Strathfield Internal Development Assessment Panel Meeting

Friday, 20 December 2019

TO: Strathfield Internal Development Assessment Panel Meeting - 20 December 2019
REPORT: IDAP – Report No. 1
SUBJECT: DA2019/140 10 CAMERON STREET, STRATHFIELD LOT 46 DP 7837
DA NO. b

Proposal: Construction of a swimming pool, alfresco area and associated landscaping.

Figure 7: Section plan

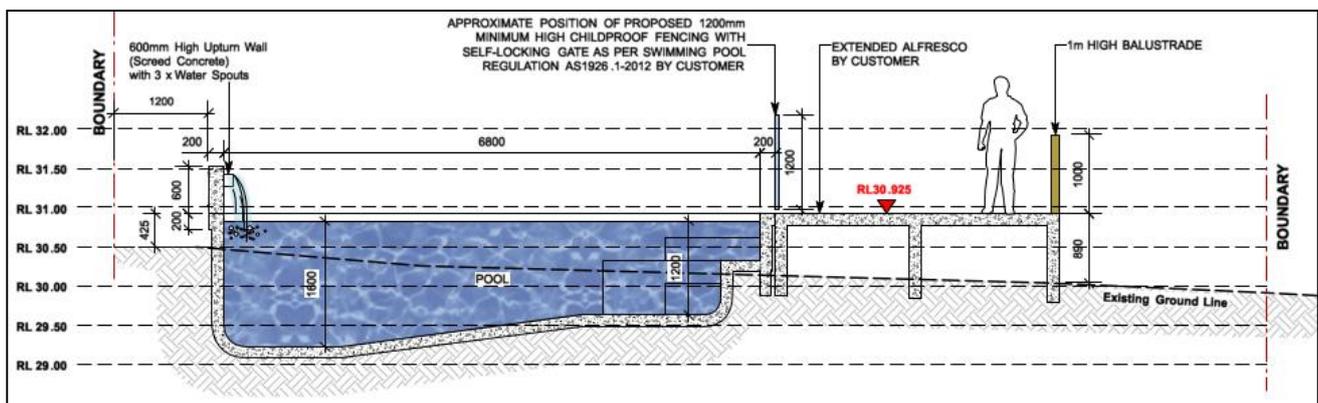
Comments: The level of the pool coping and the finished floor level of the extended alfresco area was amended during the assessment process from RL31.181 to RL30.925 to provide consistency with the approved two (2) storey dwelling on the site. However, these levels are considered to be elevated above the minimum flood level requirements for the non-habitable structures. The elevation of the extended alfresco, being 890mm above the existing ground level will provide direct overlooking opportunities into the private open space of the adjoining western property. To provide a reasonable level of visual privacy between the adjoining properties a fixed privacy screen with a minimum height of 1.7m is to be installed along the western elevation of the alfresco. Furthermore, to reduce the elevation of the proposed development a condition of consent is recommended for the finished floor level of the swimming pool coping level and concourse and alfresco to be no more than RL30.50.

Figure 6: Section plan of proposed development

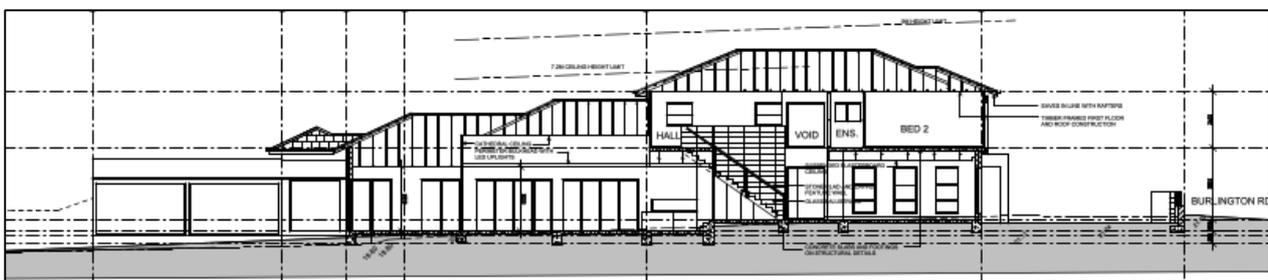
Comments: The proposed dwelling has a maximum building height of 8.12m, achieving compliance with the maximum 9.5m building height standard (Figure 6). Furthermore, the proposed height responds appropriately to the building rhythm of the streetscape.

Figure 9: Winter solstice shadow diagrams of the proposed development.

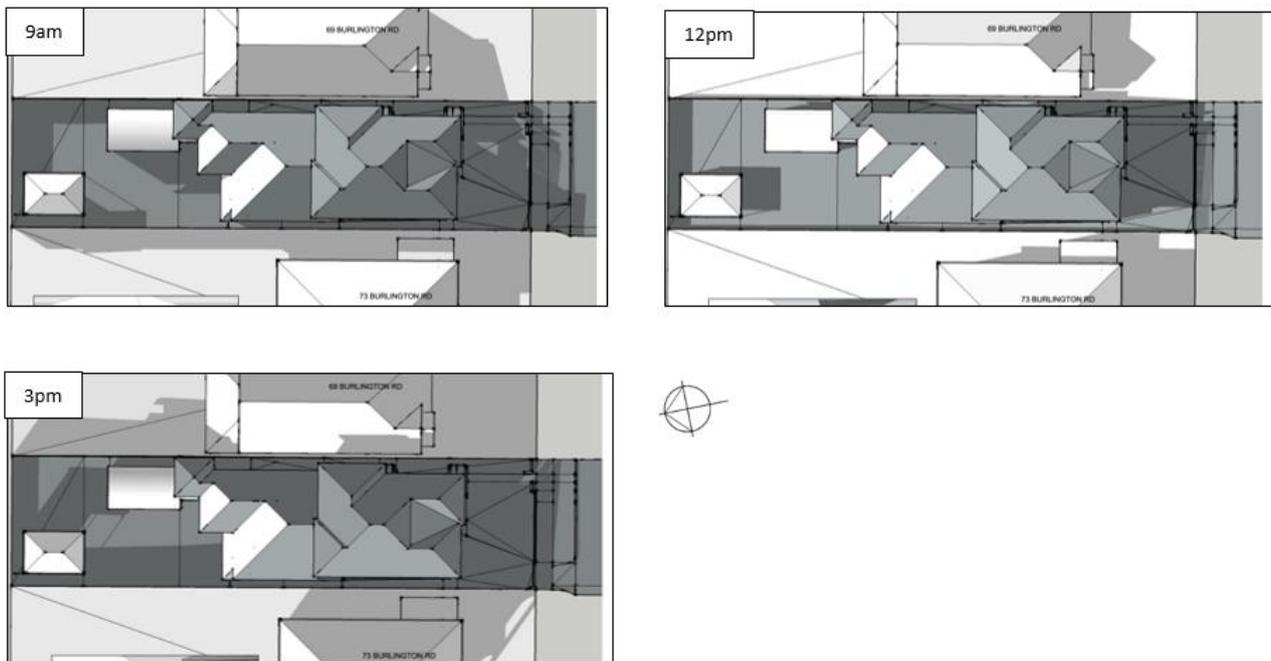
Comments:The north-south orientation of the subject site enables the adjoining properties to maintain three (3) hours of solar access to habitable rooms and private open space (Figure 9). Further, the dining room and alfresco are located towards the rear of the dwelling to optimise the northerly solar access.

Figure 14. Modification to Southern Dwelling and Pool. T13 – the Tallowwood (*Eucalyptus microcorys*) tree is indicated in red.

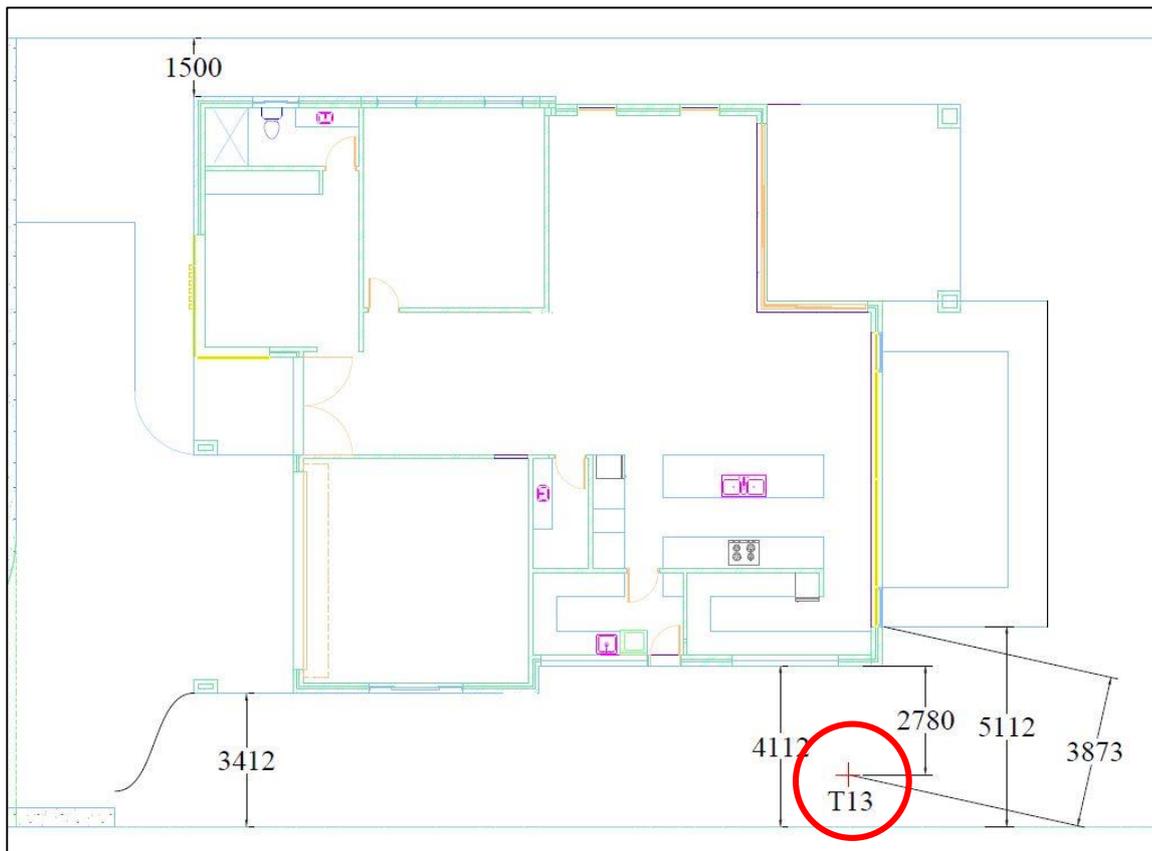
- The entire southern dwelling (including alfresco area) must be situated closer to the eastern side boundary and must have a setback of 1.5m from this boundary;
- The entire southern dwelling (including alfresco area) must have a setback of at least 4.112m from the western side boundary; and
- The entire pool must have a setback of at least 5.112m from the western side boundary.

A diagram of this modification is shown in Figure 14 below.

Additionally, conditions are recommended for ensuring that any works situated within 3m of the Tallowwood (*Eucalyptus microcorys*) will require supervision by a qualified arborist to ensure that these works do not compromise the health and stability of this tree.
